Board of Public Utilities

Memo

To: All Prospective Bidders
From: BOPU, Capital Projects Engineer, David Mann
Date: August 28, 2024
Subject: Addendum 01 for the Sherard Electrical Room Roof Replacement

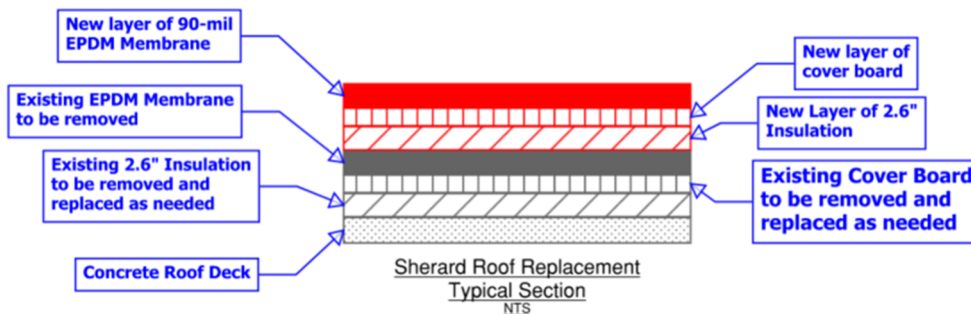
14. It appears the existing cover board is to be retained except a small section where it is anticipated the existing insulation is damaged and will need to be replaced. Can you confirm that?

Confirmed. Only the existing insulation and coverboard that is damaged is to be removed and replaced. A full new roof system will be installed on top of the existing insulation and coverboard after the damaged sections of existing cover board and insulation have been removed and replaced.
